APPLICATION NO.	FILING DATE	FIRST NAMED INVENTOR	ATTORNEY DOCKET NO.	CONFIRMATION NO.
10/501,619	05/25/2005	Joachim Christ	37742-97114 2228	
23644 RAPNES & TI	7590 08/21/2007 HORNBURG LLP	EXAMINER		
P.O. BOX 278	6	NGUYEN, XUAN LAN T		
CHICAGO, IL	60690-2786		ART UNIT	PAPER NUMBER
			3683	
			MAIL DATE	DELIVERY MODE
		•	08/21/2007	PAPER

A 1' 1' A1					
	Application No.	Applicant(s)				
Office Action Summany	10/501,619	CHRIST, JOACHIM				
Office Action Summary	Examiner	Art Unit				
	Lan Nguyen	3683				
The MAILING DATE of this communication app Period for Reply	ears on the cover sheet with the o	correspondence address				
A SHORTENED STATUTORY PERIOD FOR REPLY WHICHEVER IS LONGER, FROM THE MAILING DA - Extensions of time may be available under the provisions of 37 CFR 1.13 after SIX (6) MONTHS from the mailling date of this communication. - If NO period for reply is specified above, the maximum statutory period w - Failure to reply within the set or extended period for reply will, by statute, Any reply received by the Office later than three months after the mailing earned patent term adjustment. See 37 CFR 1.704(b).	ATE OF THIS COMMUNICATION 16(a). In no event, however, may a reply

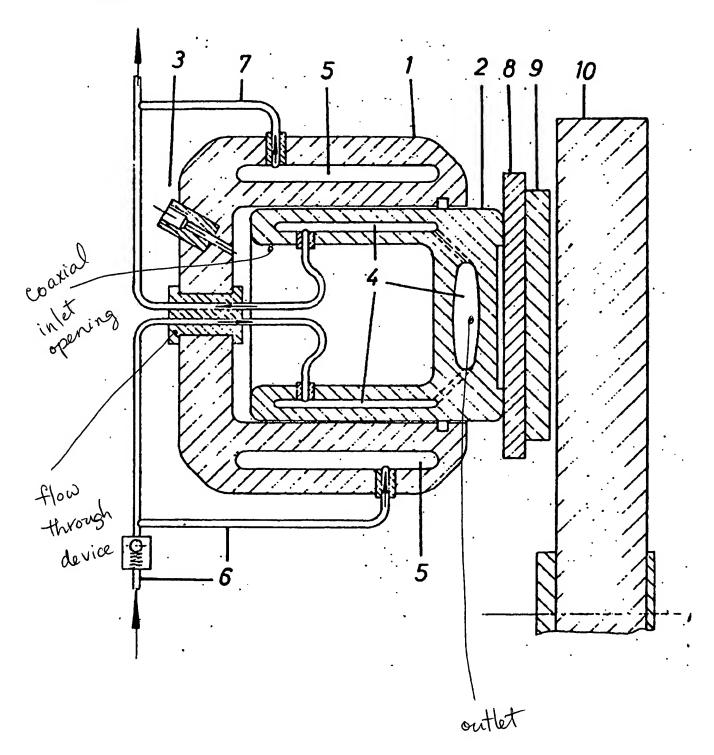
Re: claim 12, Fuchs shows a brake caliper in figure 1, as in the present invention, having a caliper wall, the caliper wall defining a cylinder 1 with at least one axially displaceable, hydraulically actuated piston 2 received in the cylinder, with which a brake pad 8, 9 can be pressed against a brake disc 10, the piston defining a cavity 4 therewithin, with at least one inlet opening for feeding a cooling medium into the cavity, the inlet opening being arranged in the piston spaced away from the brake pad, and at least one outlet opening arranged in the piston adjacent to the brake pad for discharging cooling medium from the cavity to adjacent the brake pad, as marked below, characterized in that a flow through device, as marked below, extends from the caliper wall into the interior space of the piston to allow passage of cooling medium from outside the caliper wall to the cavity, as shown. Fuchs provides examples of the cooling

medium such as oil and water but is silent about air. Ross teaches that cooling liquids and air are art recognized equivalents as cooling medium in brake cooling system in column 1, lines 12-21. Ross especially teaches the use of cooling air. It would have been obvious to one of ordinary skill in the art at the time the invention was made to have modified Fuchs' cooling system to employ air as taught by Ross to cool the disc brake since air and cooling liquids are art recognized equivalents as cooling media in brake cooling systems; and by using air, the weight of the vehicle would not be increased in order to accommodate extra cooling liquid.

Re: claim 13, Fuchs shows the flow through device to be integral with the wall of the brake caliper, as shown.

Re: claim 14, Fuchs also shows the piston comprises a hollow cylinder having a pair of face ends, wherein the brake pad 9 is located on one of the face ends and an inlet opening, as marked below, through which the flow-through device extends, is defined on the other face end, the inlet opening being coaxial to the cylinder, as shown below.
